CALL NO. 105
CONTRACT ID NO. 141025
ADDENDUM # 2

Subject: Fayette County, STP 1601 (026)
Letting May 30, 2014

- (1) Revised - Plan Sheets - R2b & R2e
- (2) Revised - Bid Items - Pages 101-103

ROADWAY TYPICAL SECTIONS

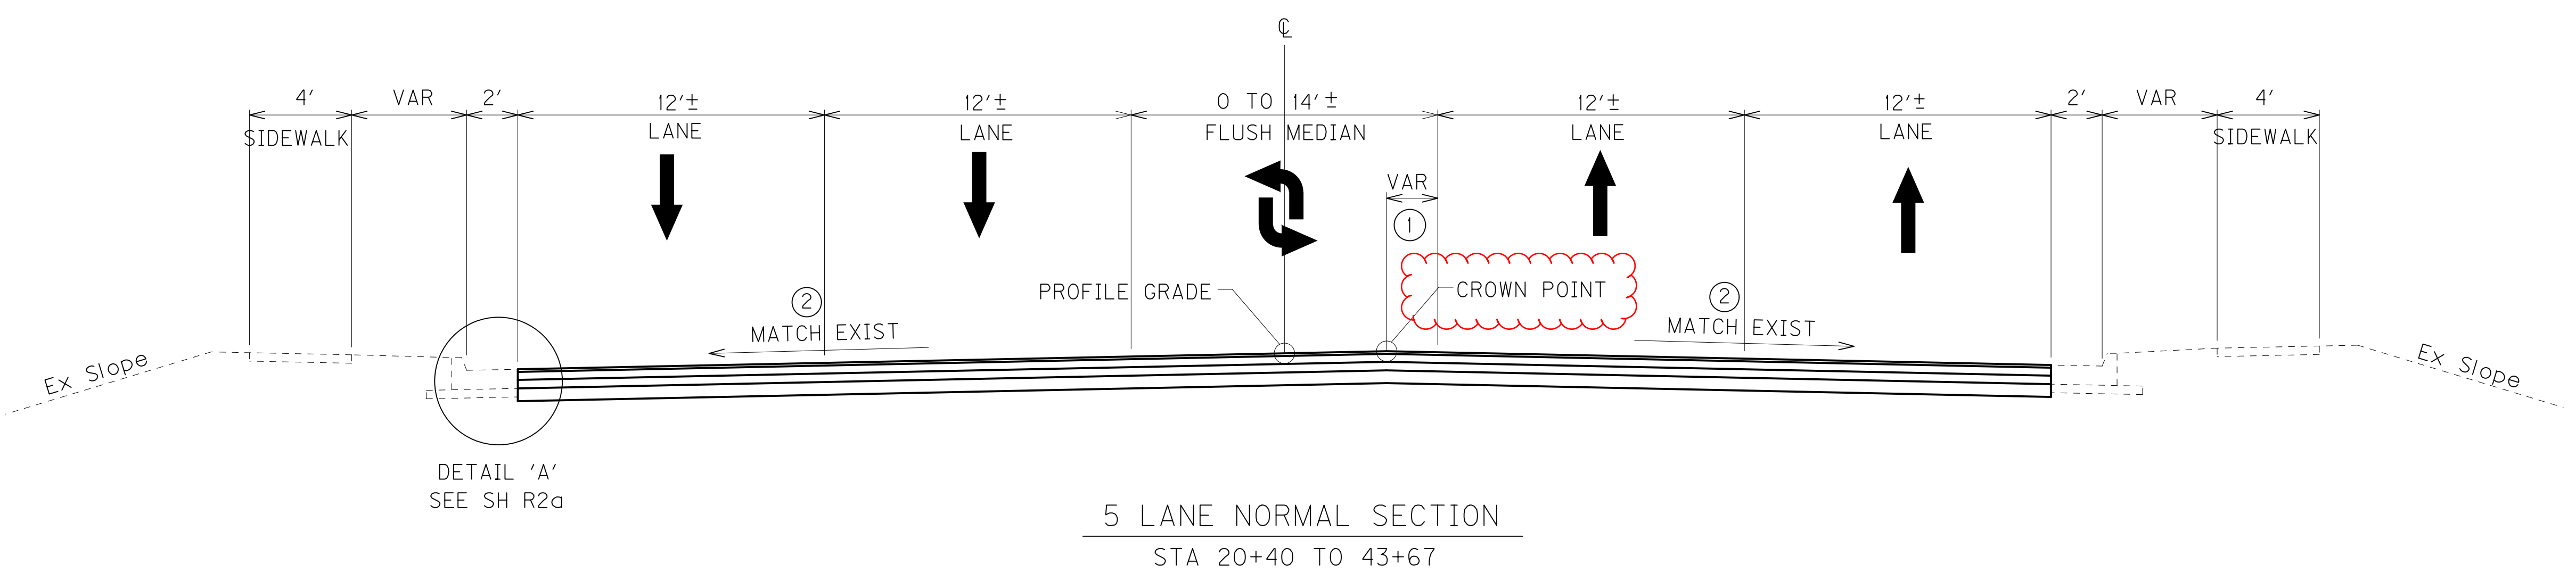
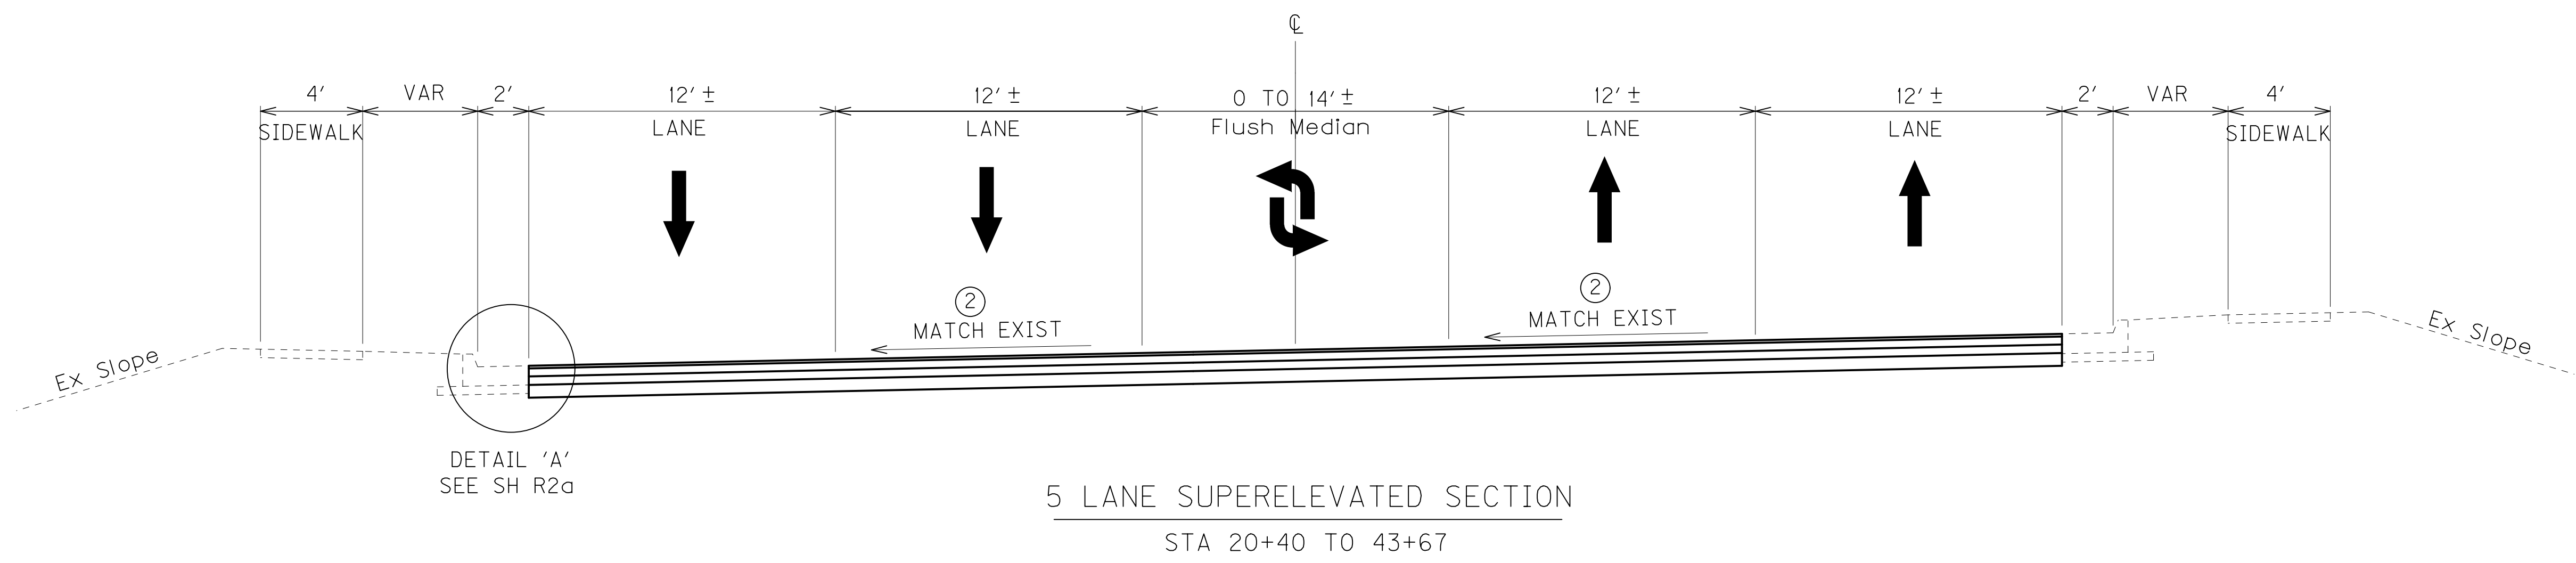
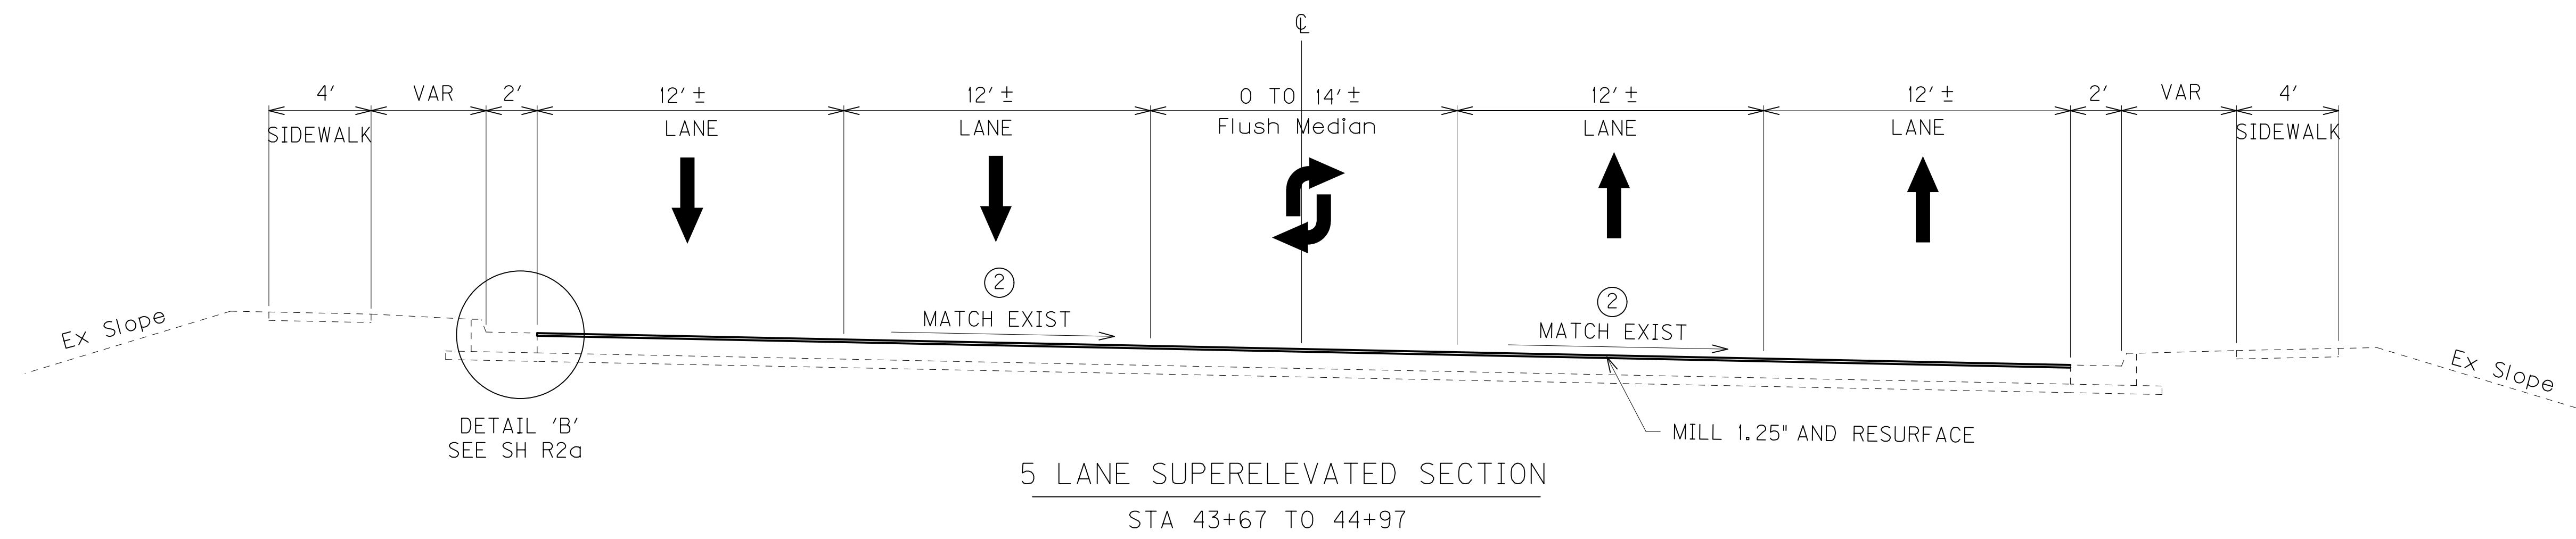
REVISED 05-19-2014
